The Regular Meeting of the
BRIAN HEAD TOWN
PLANNING COMMISSION
56 N. Hwy 143, Brian Head, UT 84719
Via Zoom Meeting ID# [85894585546](#)
www.zoom.us
Tuesday, July 20, 2021 @ 1:00 p.m.

1. RETAINING WALL REVIEW - WHARTON

STAFF REPORT TO THE PLANNING COMMISSION

SUBJECT: Retaining Wall Review
AUTHOR: Wendy Dowland
DEPARTMENT: Administration
DATE: July 21, 2020
TYPE OF ITEM: Legislative Action

Proposed Grading Plan & Retaining Wall

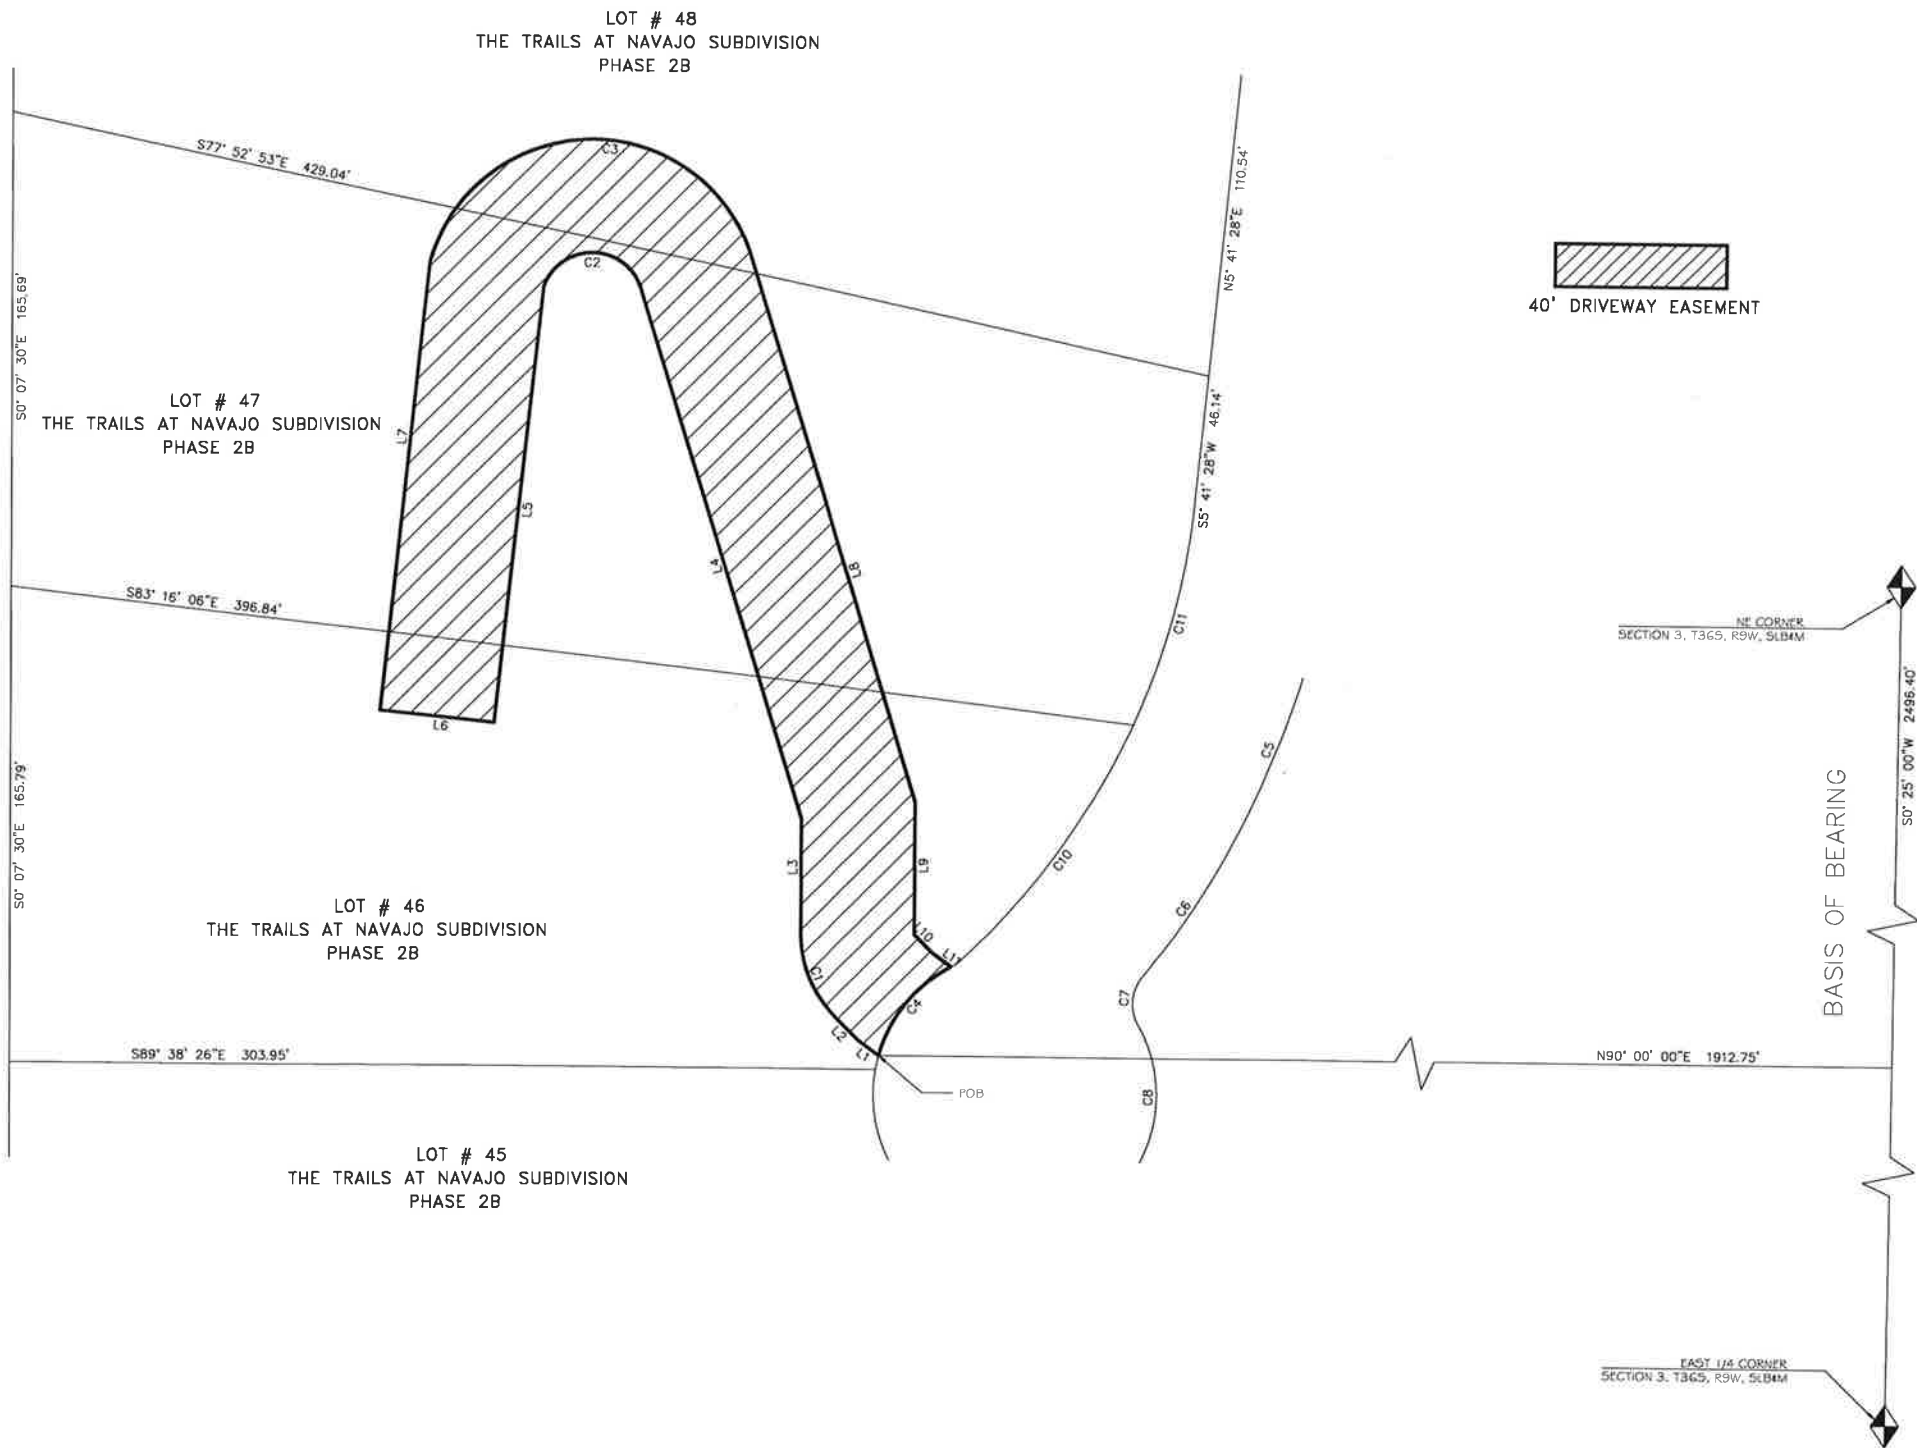
The Retaining wall will be constructed using decorative stone.

Engineered plans show the necessary length of the retaining wall.
The mass of the retaining wall is broken up by height variance and curvature.

The retaining wall does not have any sharp angles and follows the curve of the driveway.

This standard for review conflicts with the new language in LMC Chapter 10 regarding Grading and Trenching permits. Staff is unclear whether this language should have been changed when the grading permit language was changed to allow for grading, prior to a building permit, with proper engineered plans and bonding.

Staff recommends approving the retaining wall that crosses lots 46, 47, & 48 of the Trails at Navajo Phase 2B subdivision and asks for clarification from the Commission on Standard for Review number 5.

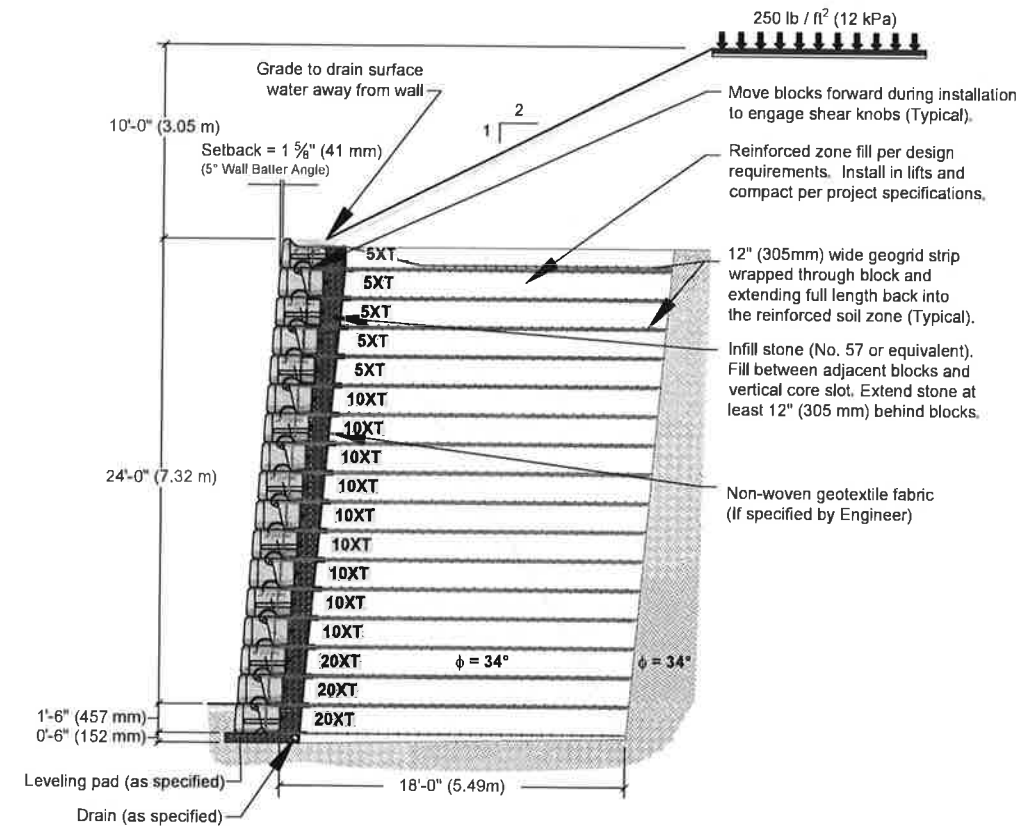
The proposed retaining wall will support a traversed driveway across lots 46, 47 & 48 of the Trails at Navajo Phase 2B subdivision. The proposed retaining wall has been engineered and will be built out of stones (see attached). The property owners would like to build further up on the hillside and intend to install the driveway prior to a building permit being issued. A permanent access easement has been recorded and bonds have been submitted. The applicant has also stated that the HOA has given approval.
